McClellan Air Force Base

Basewide Groundwater Operable Unit

Groundwater Operable Unit Remedial Investigation/ Feasibility Study Report

SUBJECT: Groundwater (GW) Operable Unit (OU) Final Remedial Investigation/Feasibility Study (RI/FS) Document

FIGURE E-2
MOST RECENT SAMPLING DATES
 FOR ZONE B MONITORING WELLS
 GROUNDWATER OPERABLE UNIT RI/FS
 McCLELLAN AIR FORCE BASE
 SACRAMENTO, CALIFORNIA

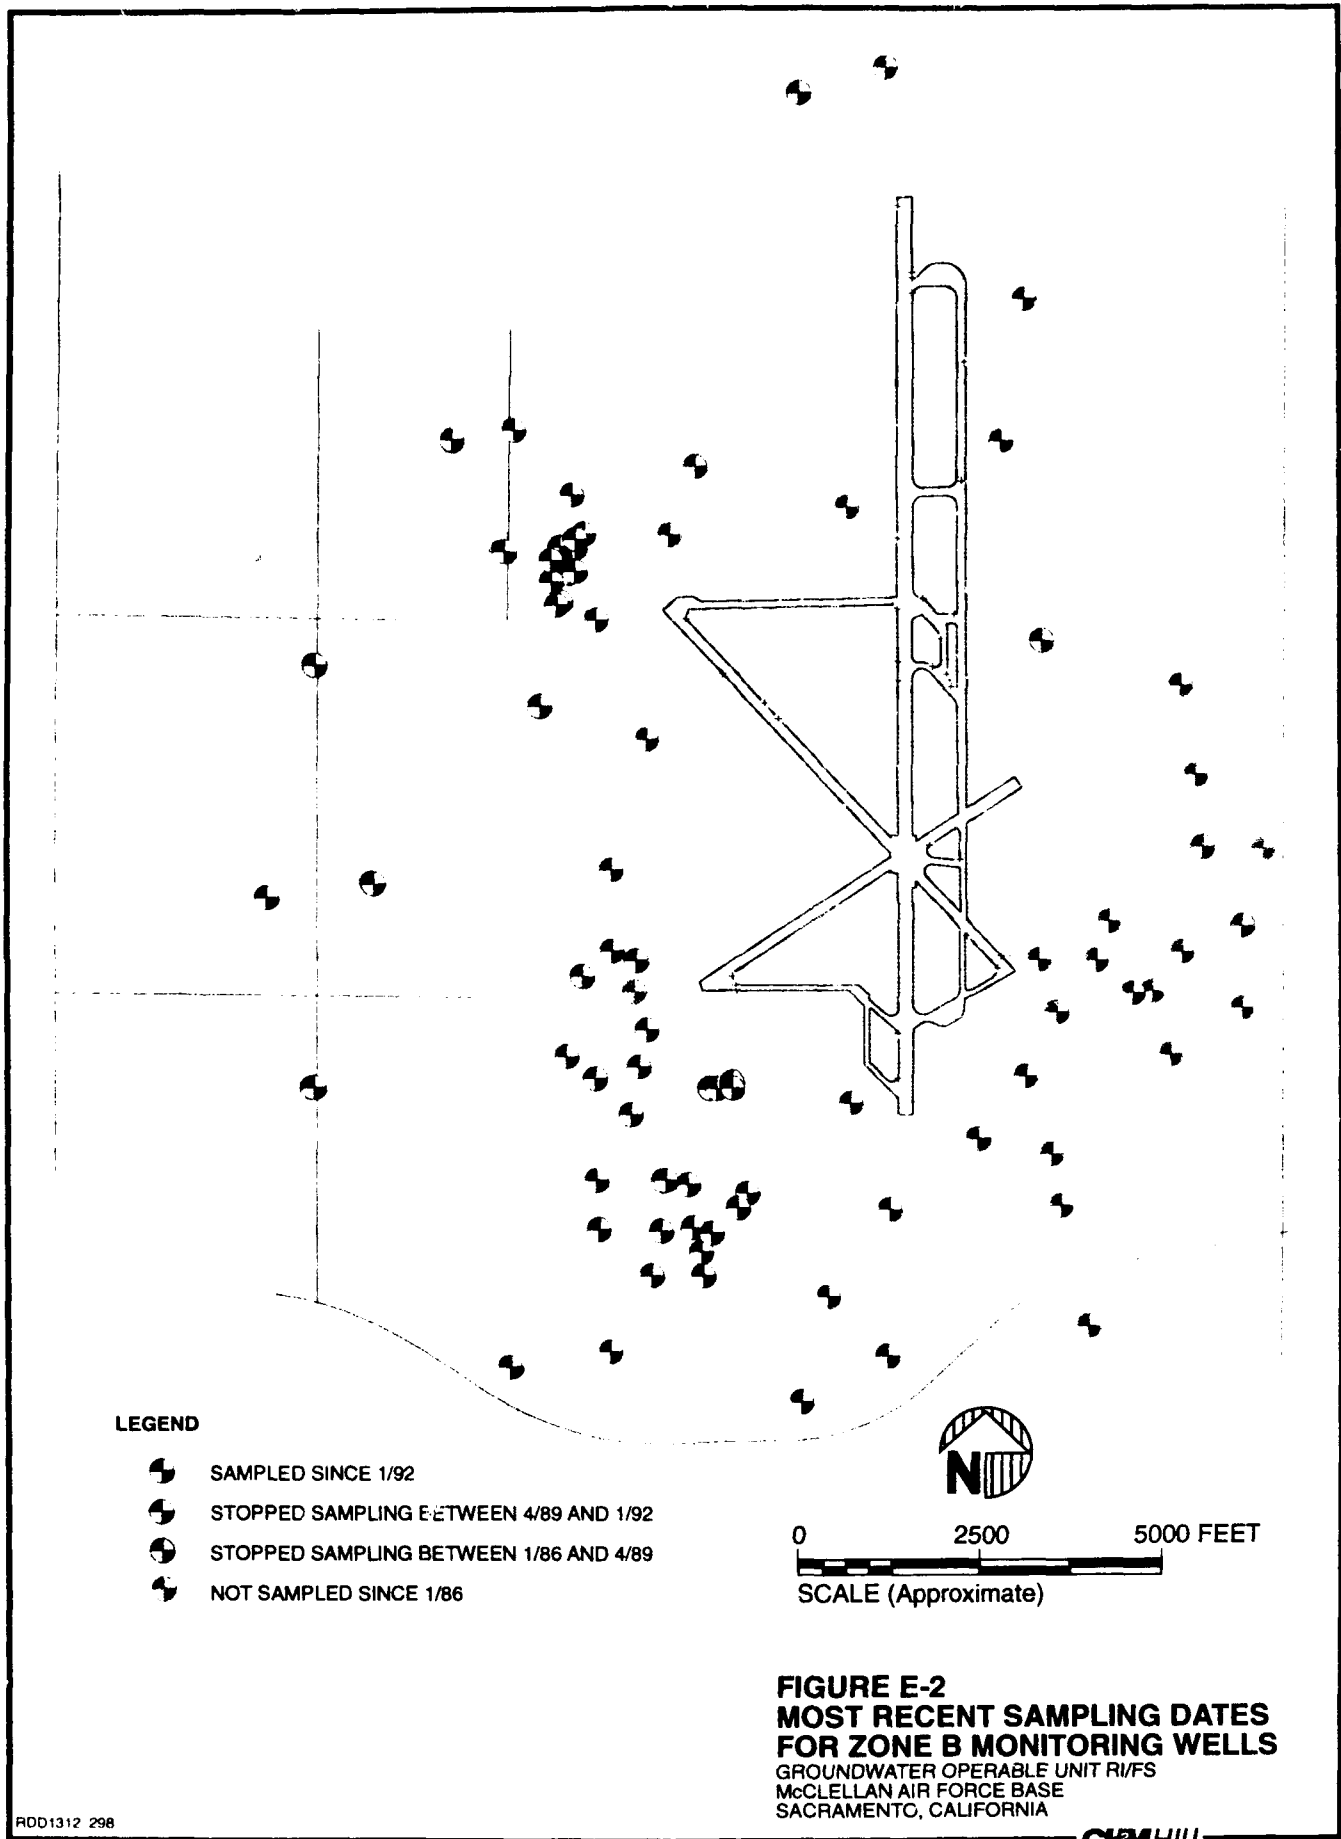
- c. Page E-1, paragraph 2. It is stated that Figures E-2 and E-3 suggest that fewer B and C Zone monitor wells have been dropped from the monitor program. That is likely due to the fact that none of those wells have gone dry and many were recently added during plume definition and PGOURI development. They were likely added in spots that necessitated continued monitoring.**

**FIGURE E-8
MONITORING AND EXTRACTION**

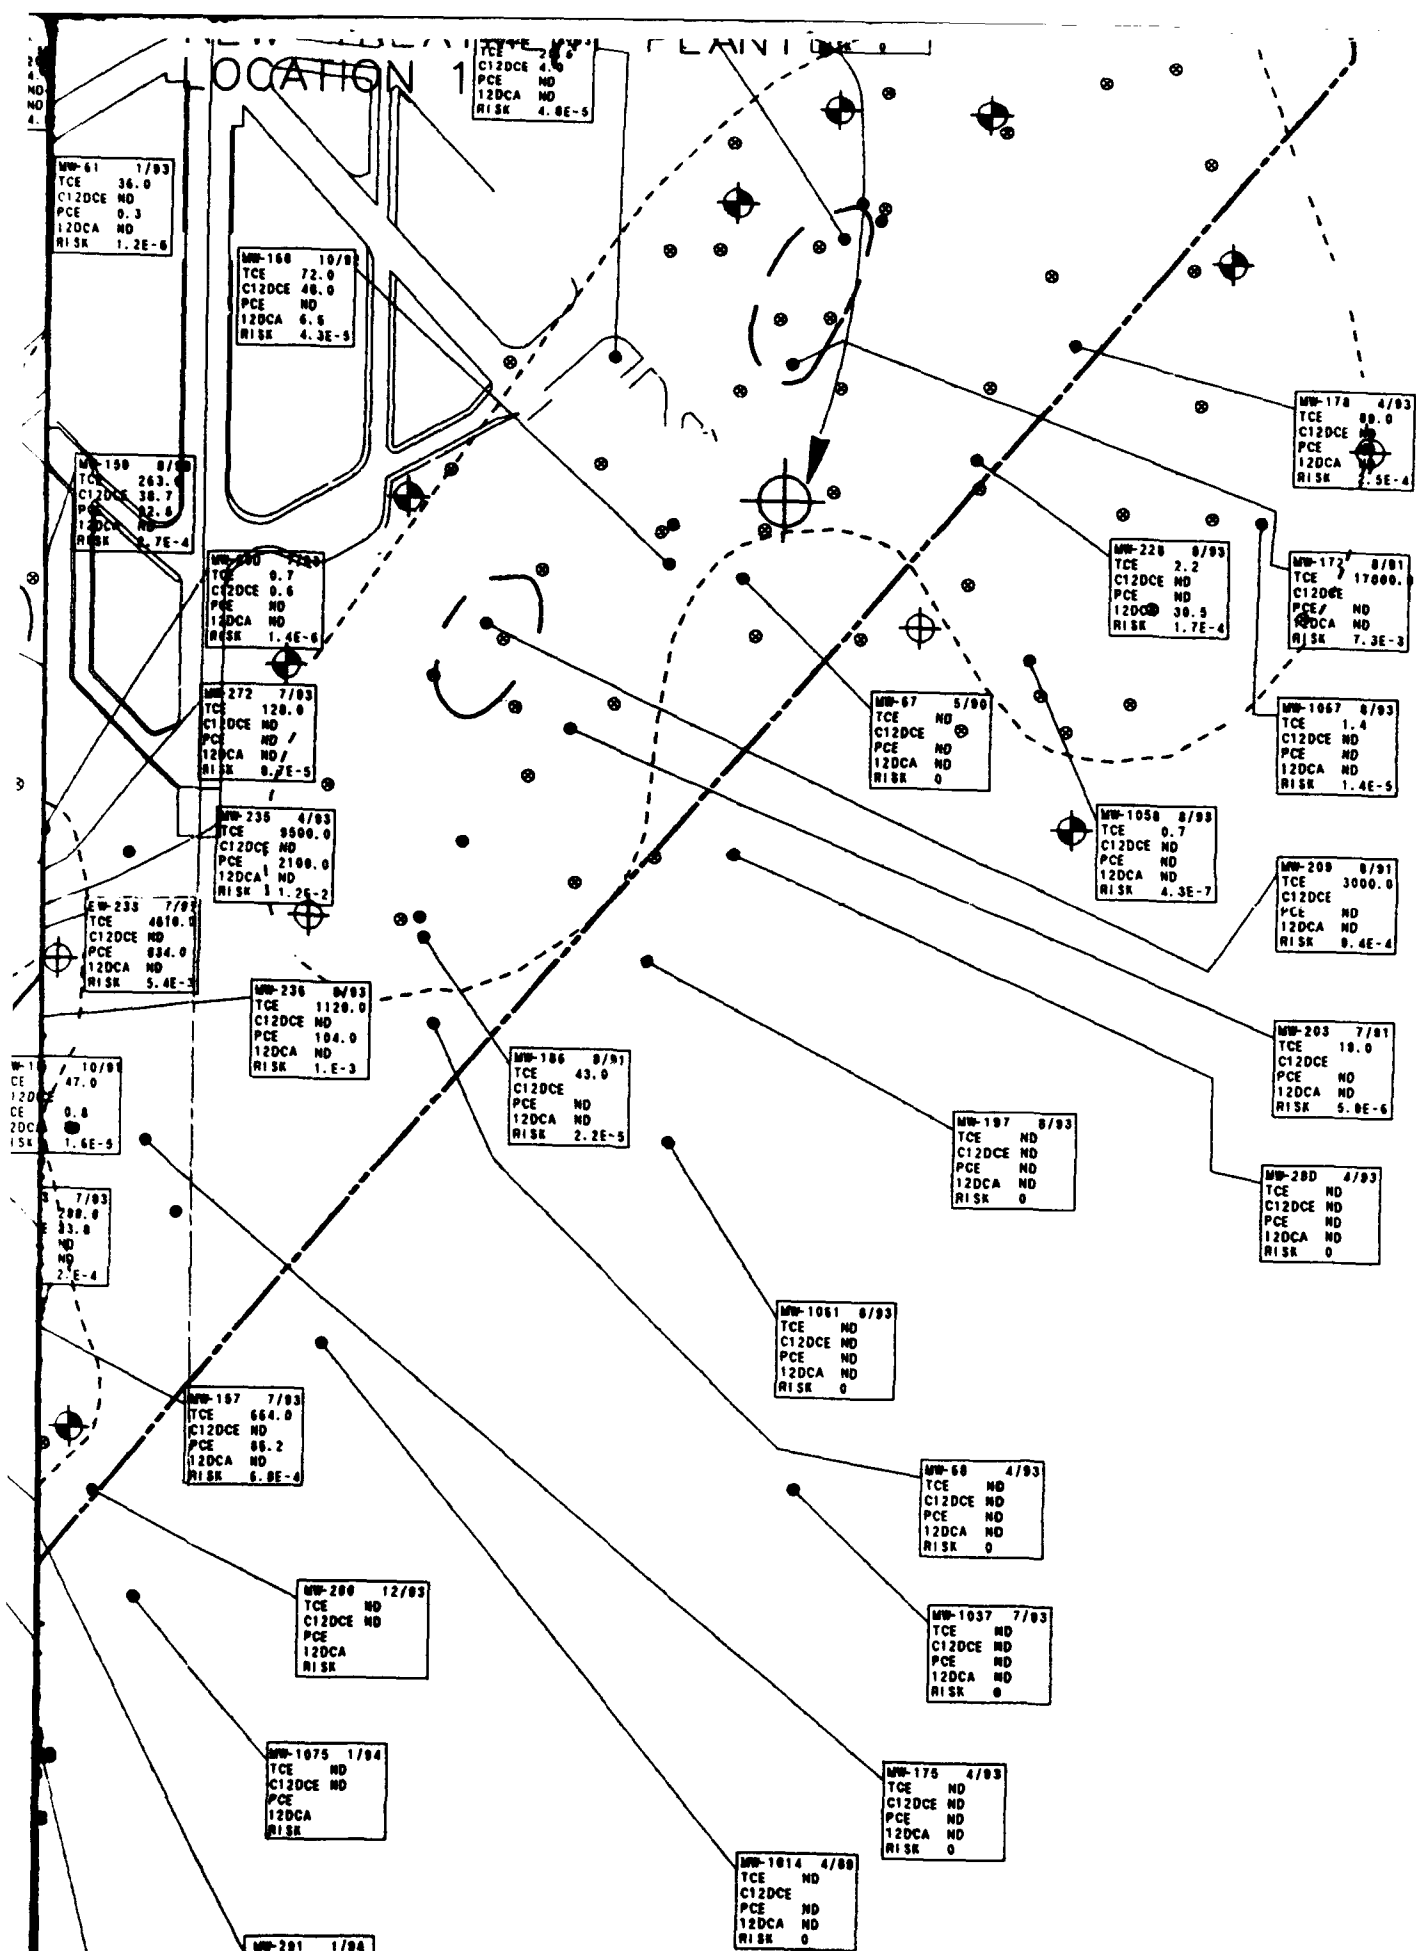
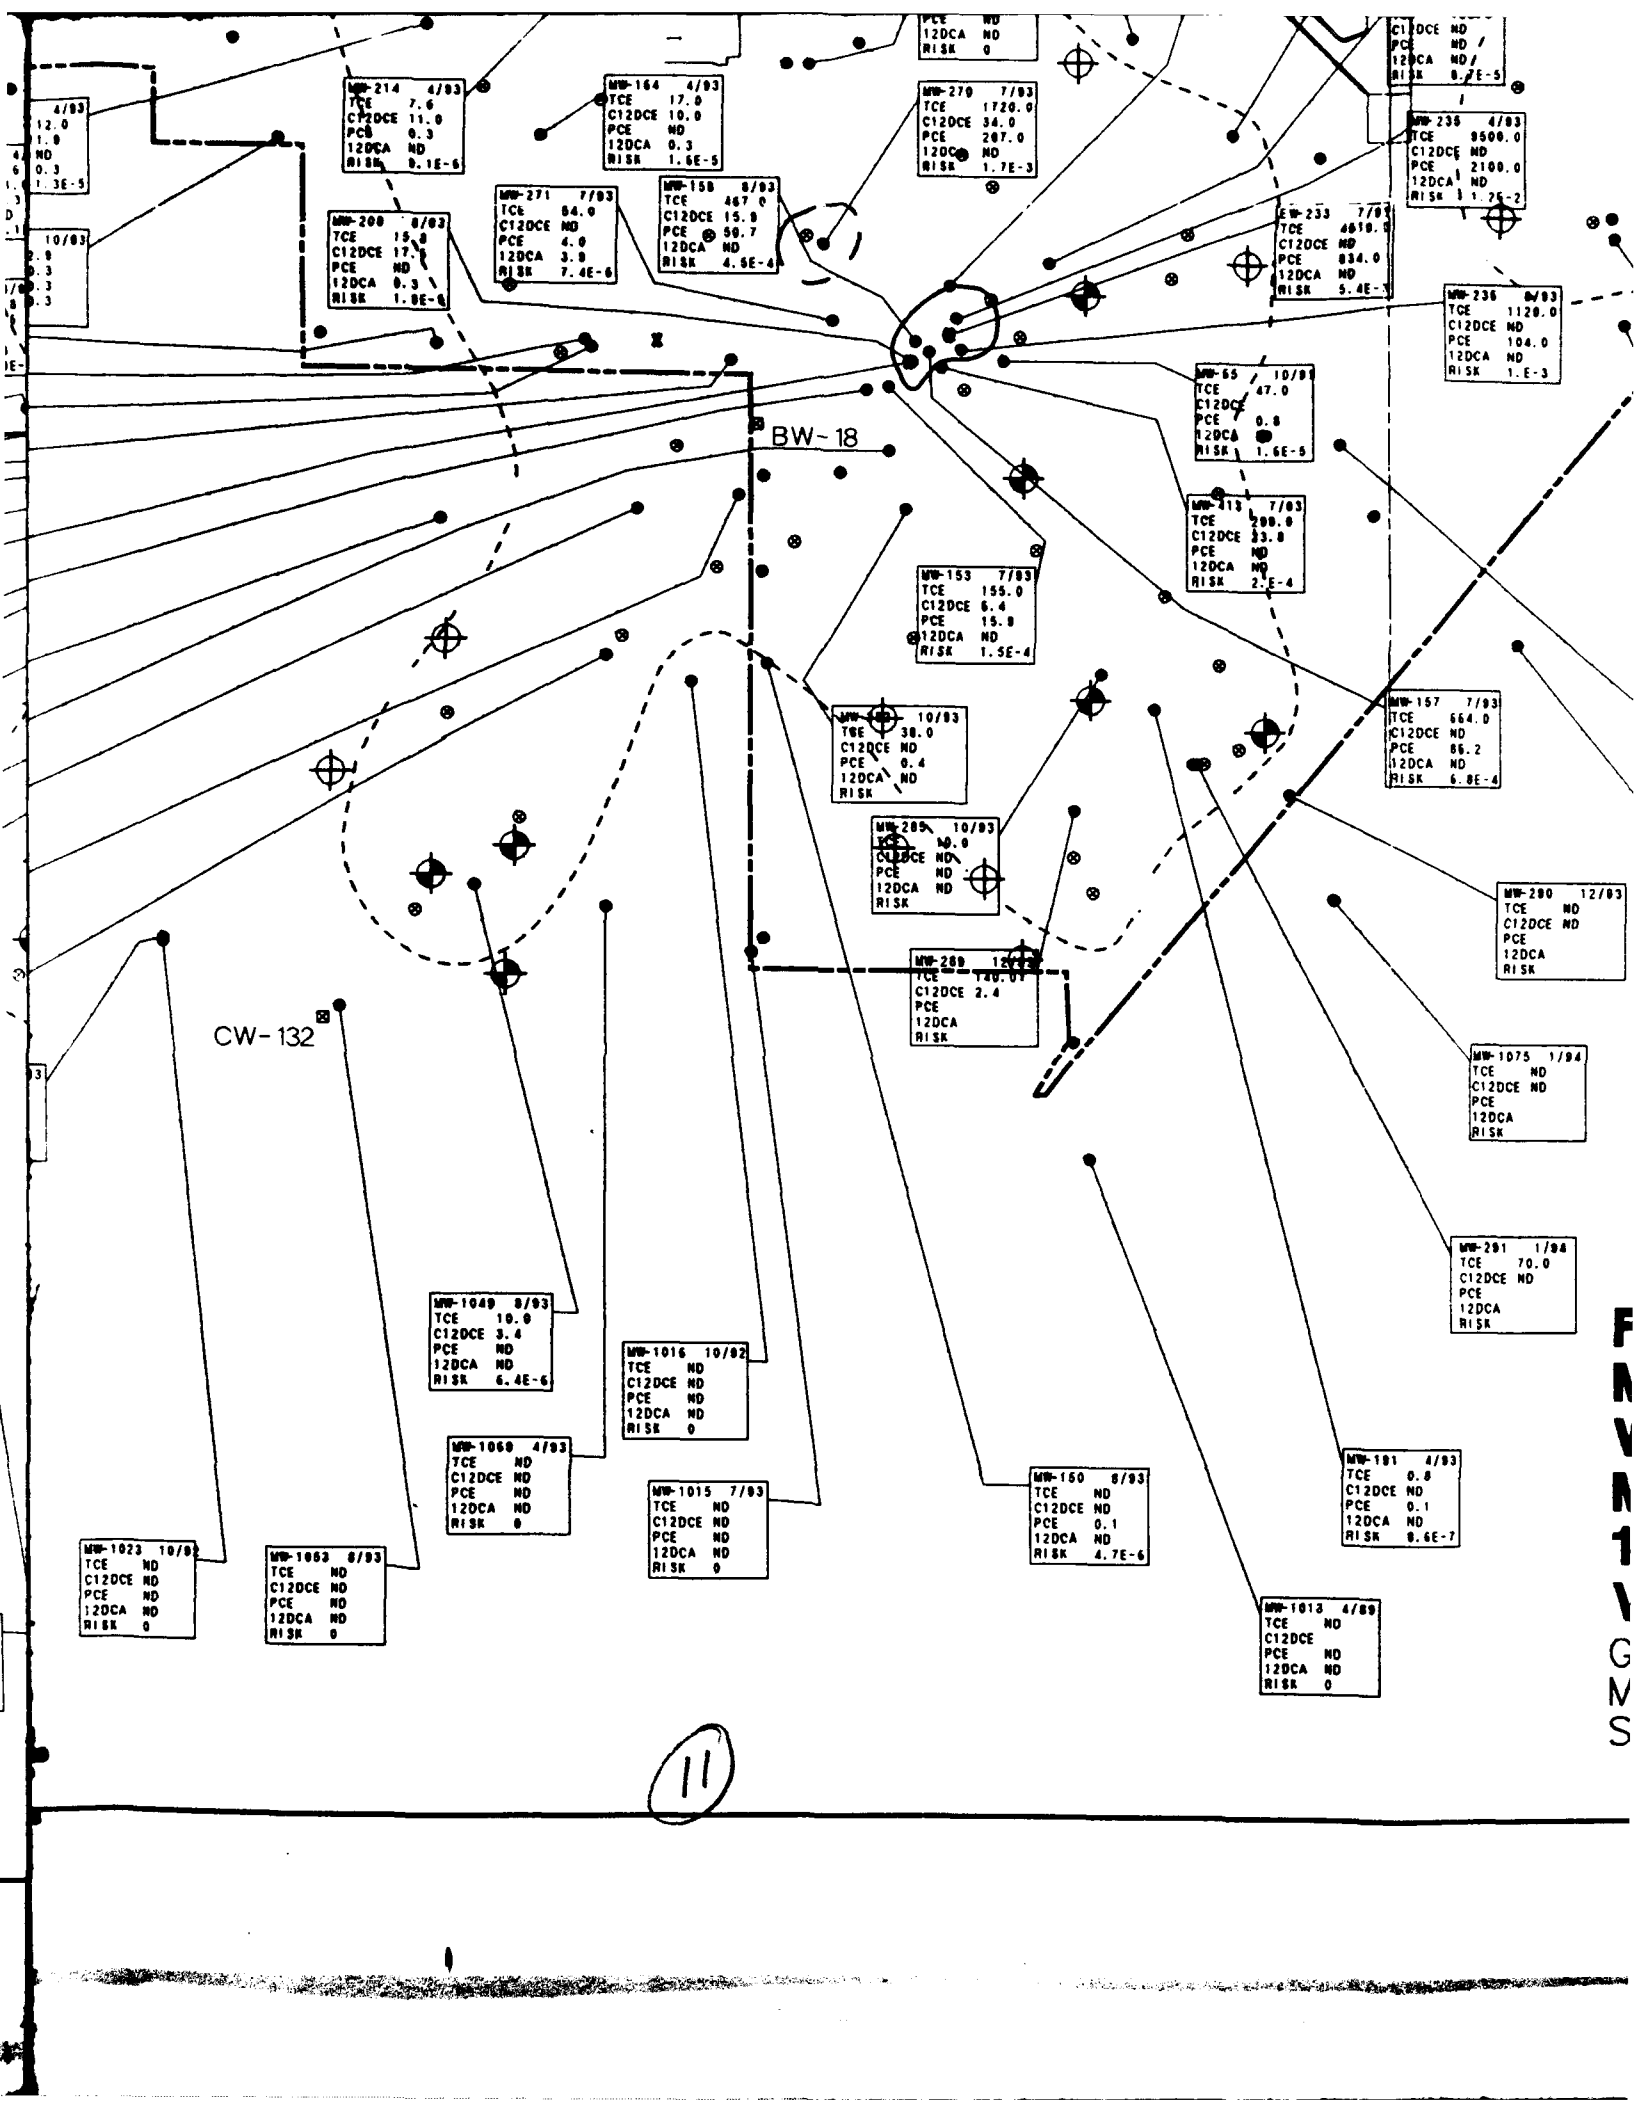
Figures E-8 and E-9. The text described the need to monitor between the A and B zones in OU-C. Neither figure proposes additional wells suggested by the text. The figures do not indicate additional wells to further define the plume emanating from OU-C1 in the B zone. The maps do not identify the OU-B EE/CA wells, or indicate the need for extraction wells around the OU-B base perimeter to prevent off-base migration when BW-18 is decommissioned.
